UNITED STATES ENVIRONMENTAL PROTECTION AGENCY

Re: December 2020 Operable Unit Two Remedial Action Work Plan
Ringwood Mines/Landfill Site, Ringwood, New Jersey

USEPA AND NJDEP COMMENTS ON THE DECEMBER 2020
OPERABLE UNIT TWO REMEDIAL ACTION WORK PLAN FOR THE
RINGWOOD MINES/LANDFILL SUPERFUND SITE

Figure 2: Proposed Truck Access Routes to Each Area

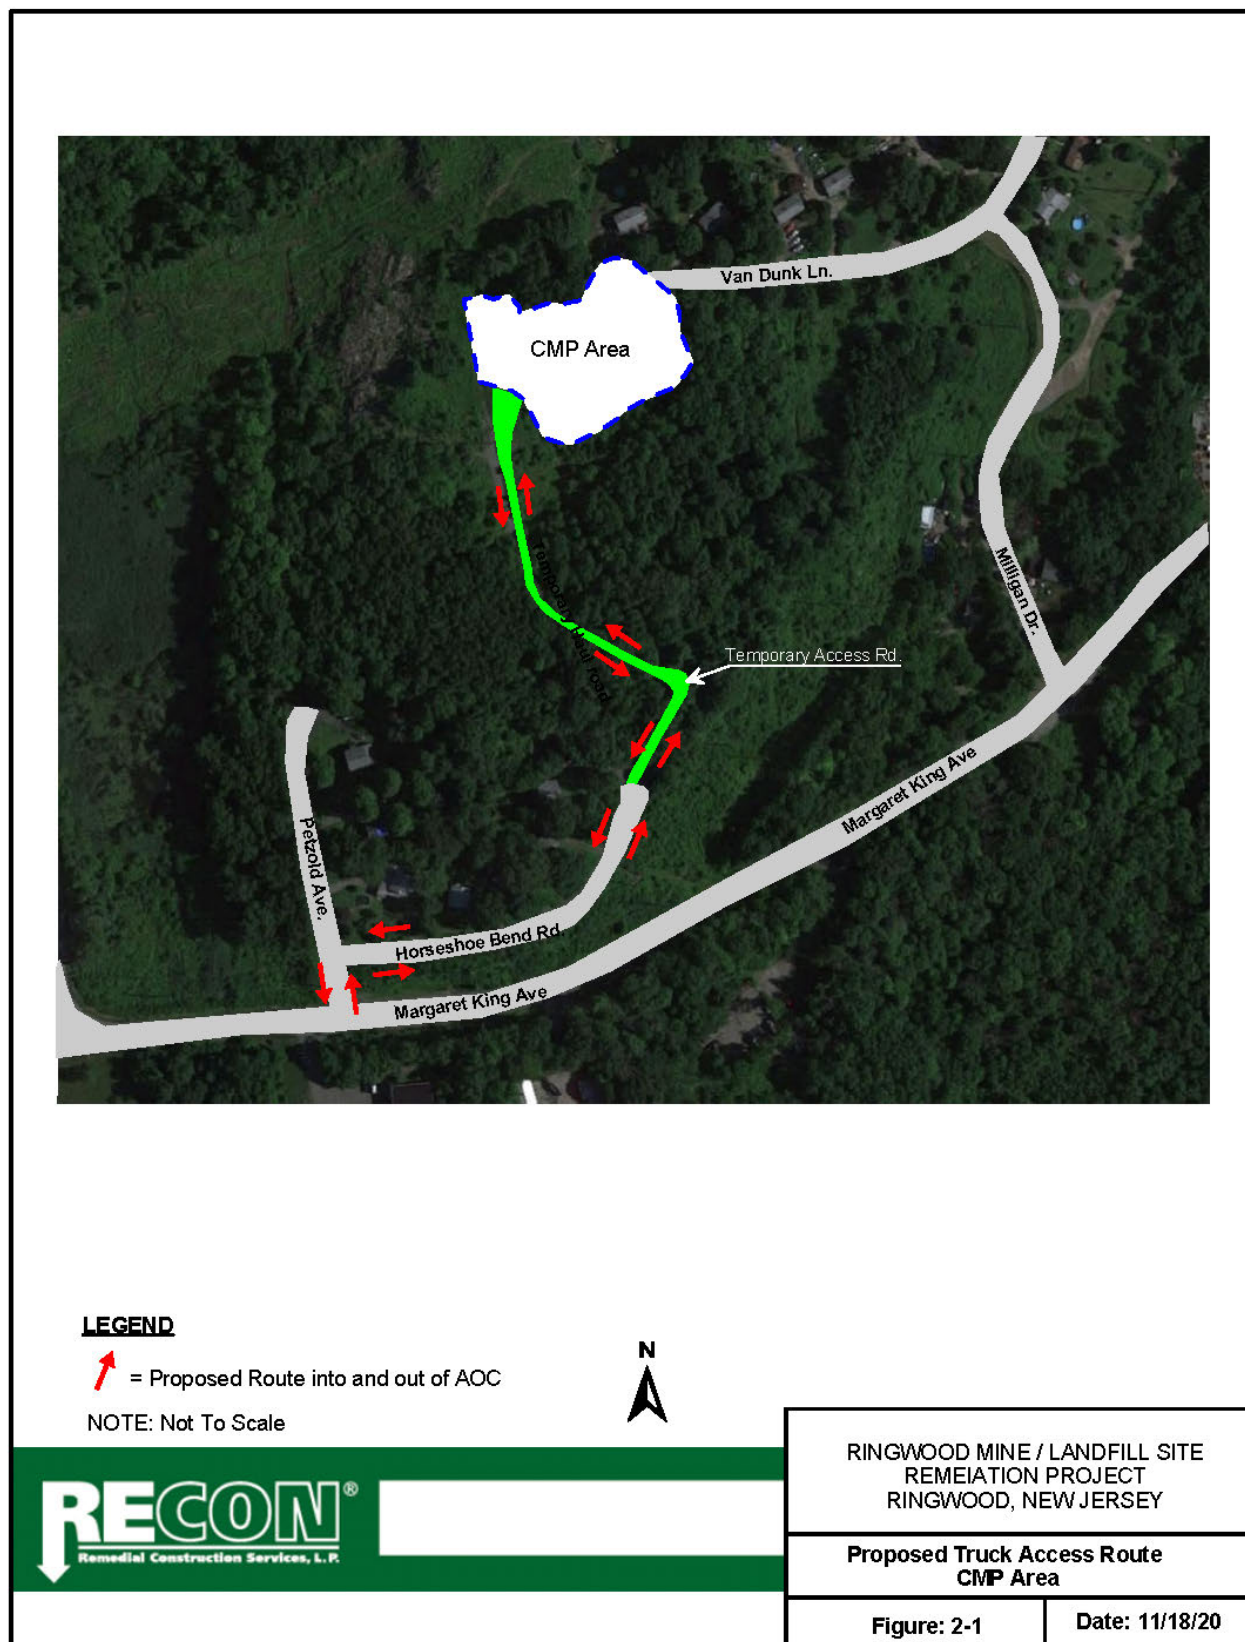
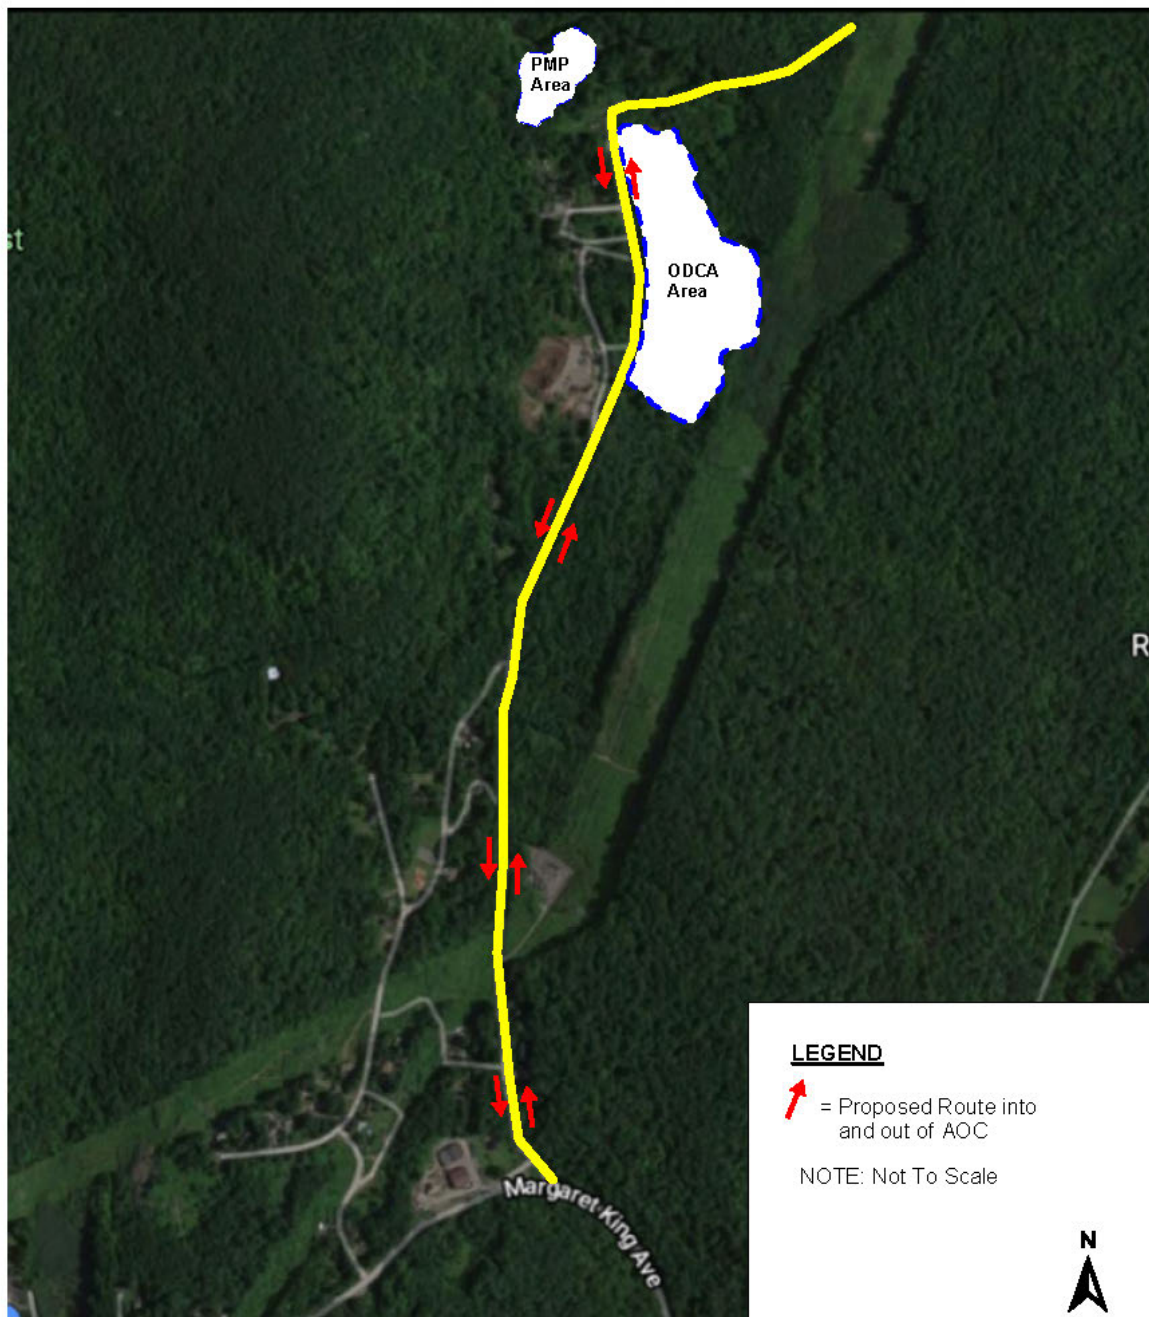
Technical Comment #11: Section 7.6 provides information about materials management. Coordination of disposal to approved facilities will occur between the contractor and Ford Motor Company. Figure 2 in this report shows proposed truck access routes. *If community members have preferences for when waste will be moved off site, such as avoiding times when school buses or children are outside, they may want to share that information with EPA.*

Figure 3: Site Layout Plans

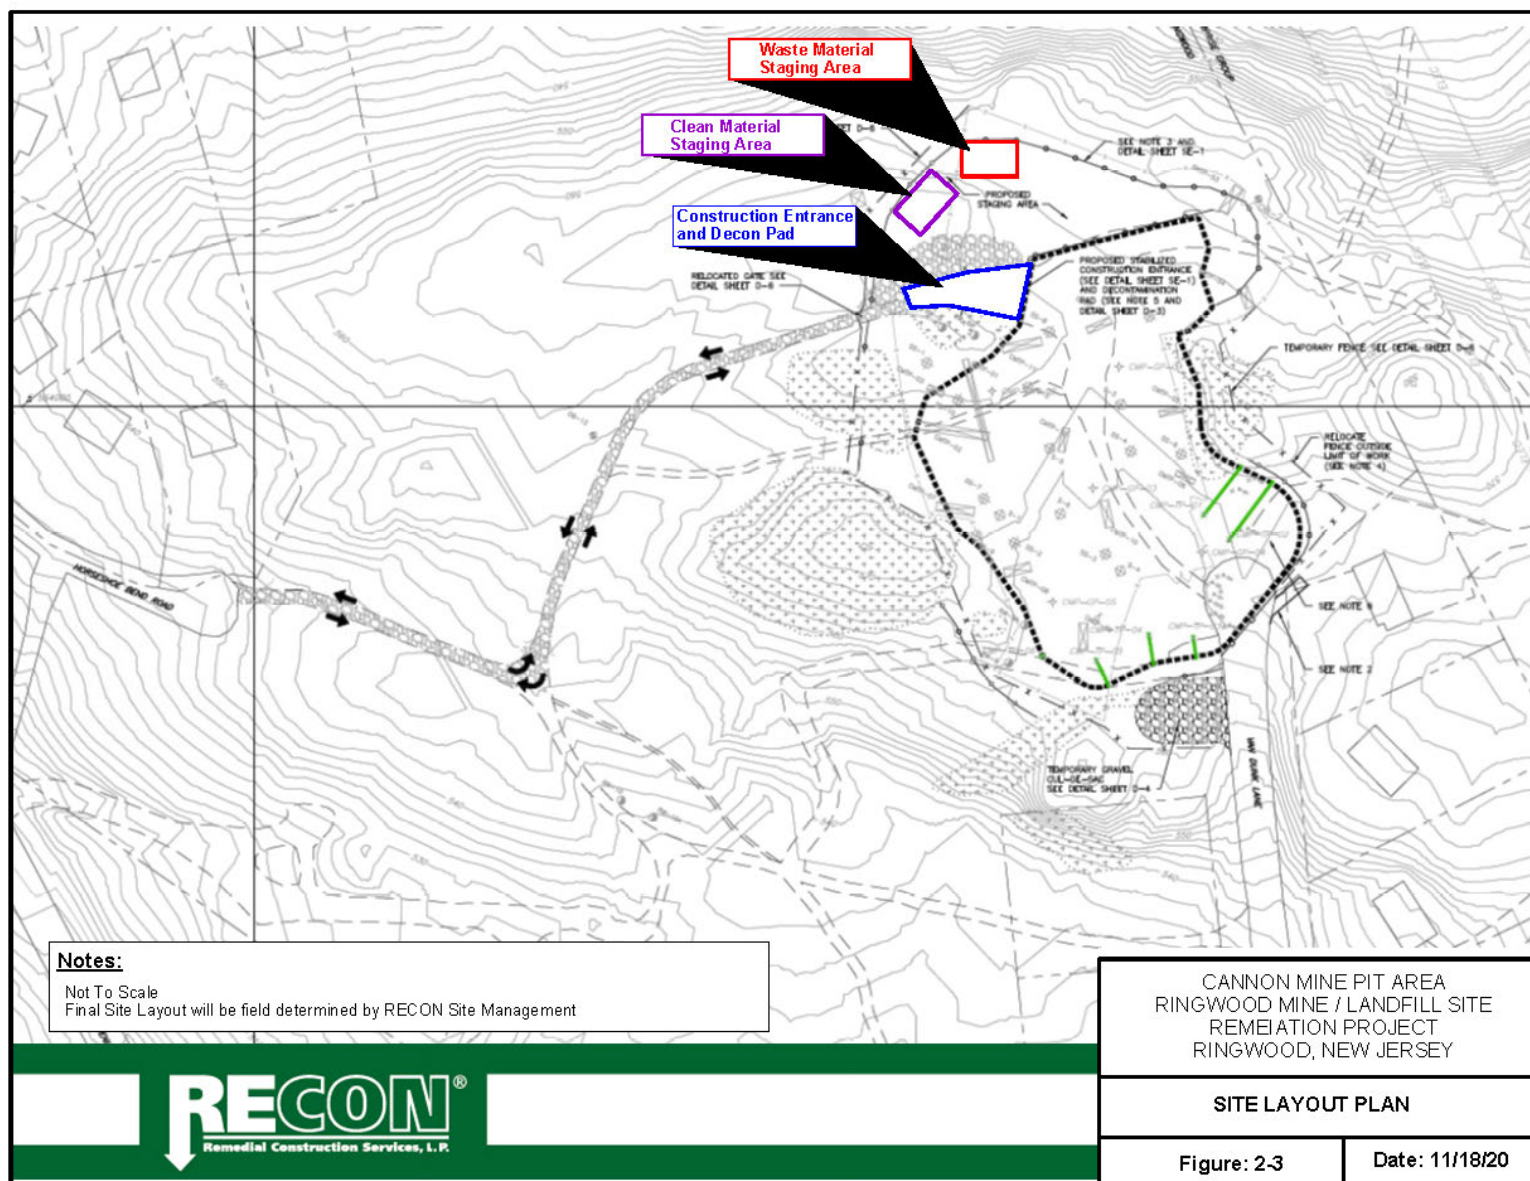
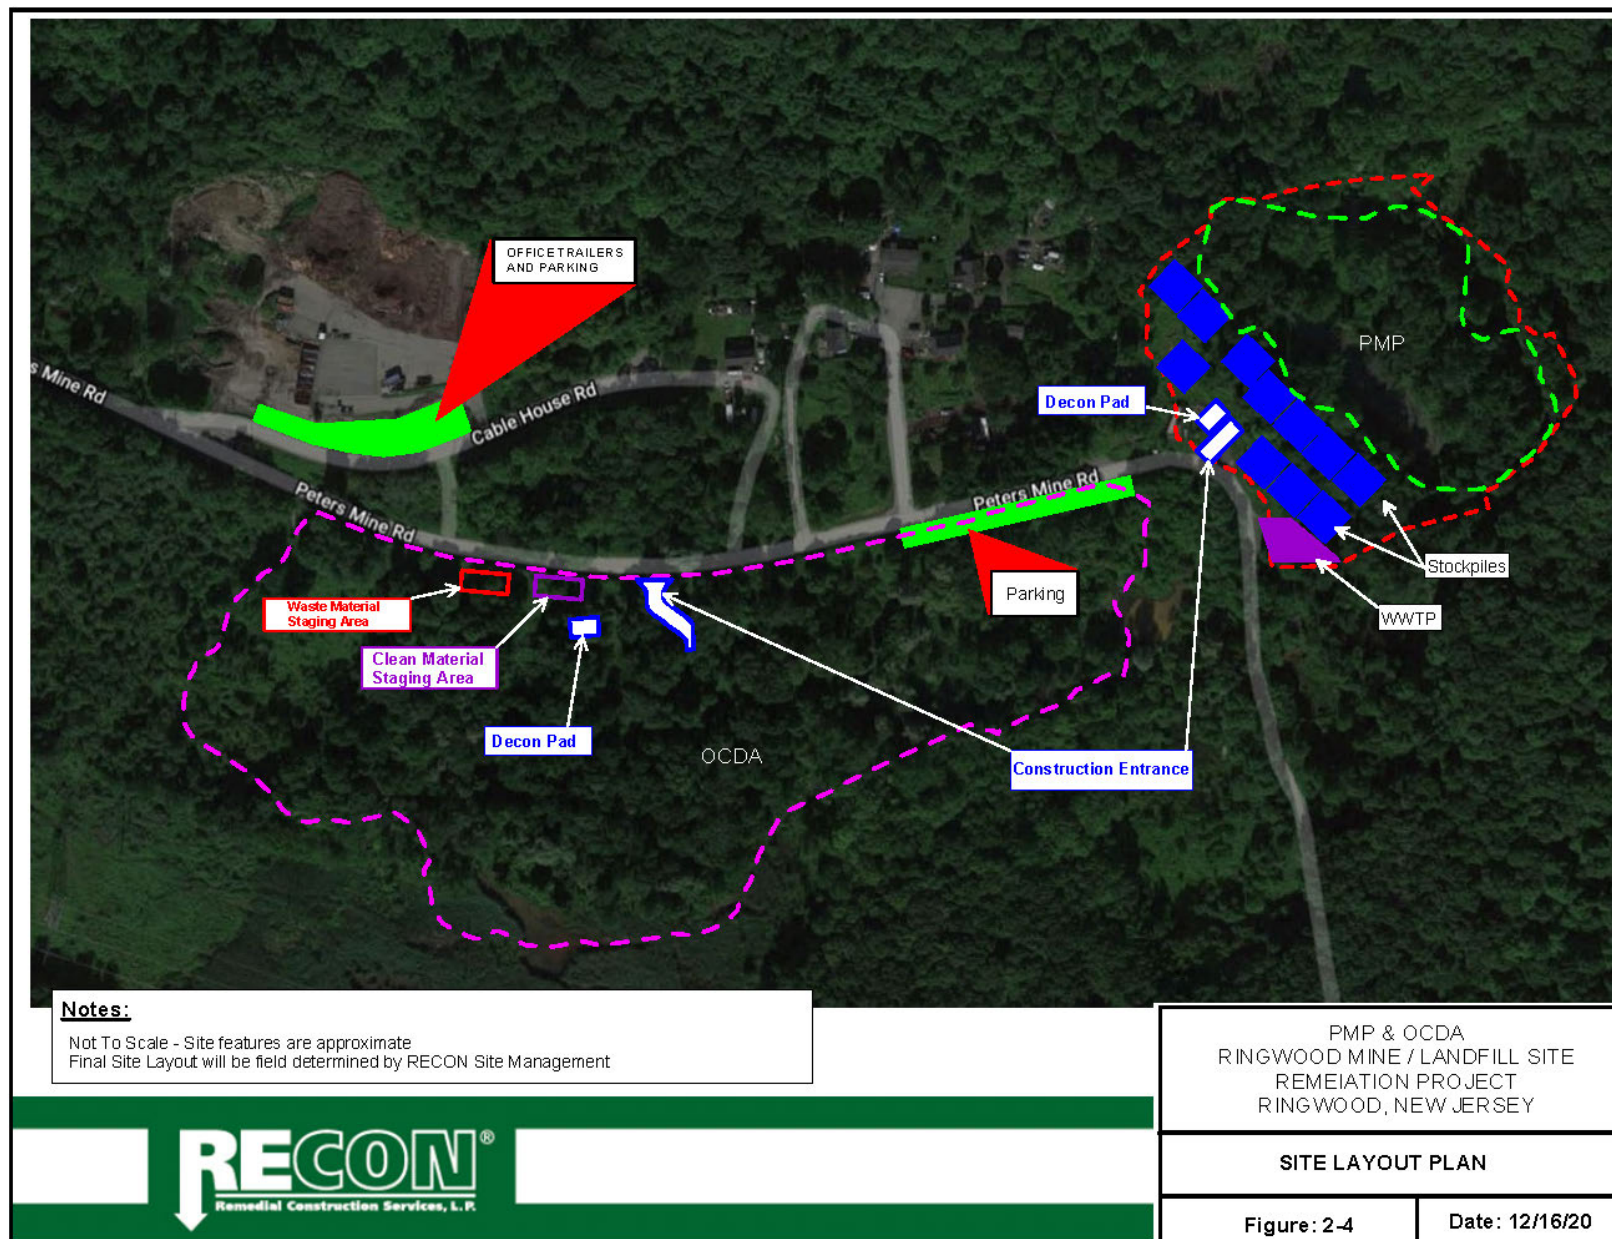
Technical Comment #4: Section 6 provides information on site mobilization and preparation. It includes subsections 6.2.1, 6.2.2, 6.2.3, 6.2.4 and 6.2.5. Each subsection addresses a specific area: the CMP Area, the OCDA and the PMP Area as well as new recycling center construction and current recycling center removal. *These sections may be of particular interest to the community. Community members may want to provide feedback on these sections to EPA.*
